Masonry Chimney #1

Flue #1

Fireplace #1

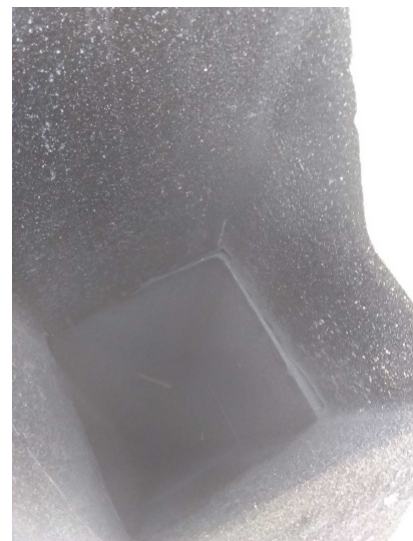
Stage 3 Glazed Creosote: During the scan of your system we found stage 3 glazed creosote. Creosote goes through 3 stages. Stage 1 being a very fine brown powder like stage. If the system is not swept or undergoes heavy use it will become Stage 2. Stage 2 Creosote is a black flakey substance often with crystallizing taking place. If Stage 2 creosote is left in the system the crystallization will transform into a sticky tar like substance with a very shiny appearance. This is Stage 3 Glazed Creosote; it is a combustible material and can catch fire if the right amount of air is allowed to find its way into the flue during use. Removing Stage 3 Creosote may require chemicals and or more aggressive forms of cleaning than standard cleaning procedures. It should be removed before further use.

The mortar joints between the flue tiles are no longer intact. These missing or deteriorated mortar joints prevent the flue tiles from properly conveying the byproducts of combustion to the exterior of the home.

Flue is coated with stage 3 glazed creosote.

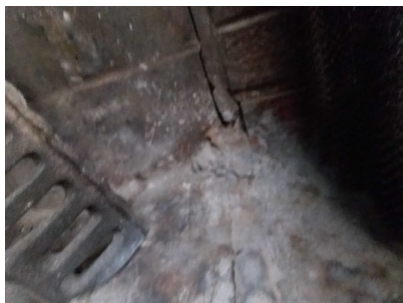
The flue tile is not sealed at the top of the smoke chamber. This can allow the byproducts of combustion to go behind the flue tiles and may migrate to areas of the chimney and home not meant to contain them. The potential hazard exists that combustible residue could built up where it cannot be maintained and allow the possibility of a structure fire. This defect could also allow carbon monoxide the enter the home. 2016 NFPA 211 11.2.1.13

There are cracks evident where the face of the fireplace meets the firebox. These cracks have the potential hazard of allowing heat, sparks and other byproducts of combustion to travel behind the facing material of the fireplace and possibly cause a structural fire. 2016 NFPA 211 11.2.1.5

The area above the damper is restricted by construction materials. Even when the damper is fully open the path for the smoke to travel is diminished and the fireplace may not draft properly. 2016 NFPA 11.2.1.3.3 IRC 2006 2111.6

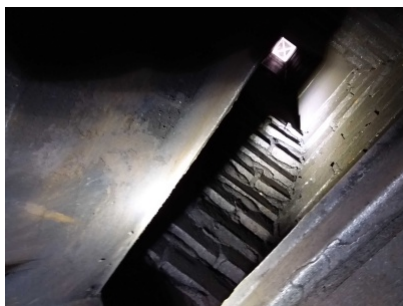
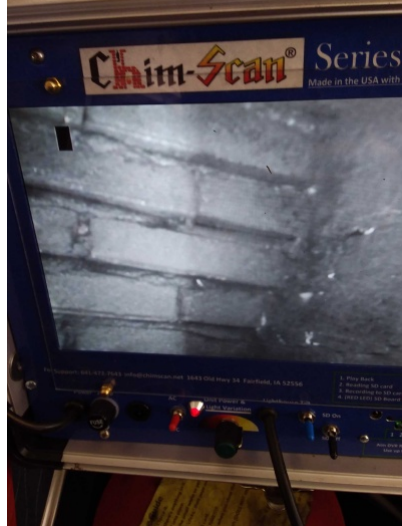
The smoke chamber is a crucial part of the fireplace system and is often the most poorly constructed area of the structure. Most structural fires associated with fireplaces originate in this area. It is imperative that this area be completely sealed and parged smooth. 2016 NFPA 211 11.2.1.13 IRC 2006 2111.S

The smoke chamber walls are not parged smooth. This can cause a chimney to draft poorly. Lack of the parging material may also increase the risk of a structural fire and the risk of the byproducts of combustion migrating into the home. 2016 NFPA 211 11.2.1.13 IRC 2006 2111.S

Smoke chamber is coated with stage 3 glazed creosote.

The floor of the firebox has cracks in the mortar and / or bricks or the bricks are pitted. The floor of the firebox needs repaired.

There are gaps in the mortar joints. The smallest gap in the masonry can create a pathway for rogue flue gases to be drawn into areas of the structure that could pose a potential fire or carbon monoxide threat. Fireboxes are to be laid with refractory mortar that can withstand heat and moisture. 2016 NFPA 211 11.2.1.4 IRC 2006 2111.5
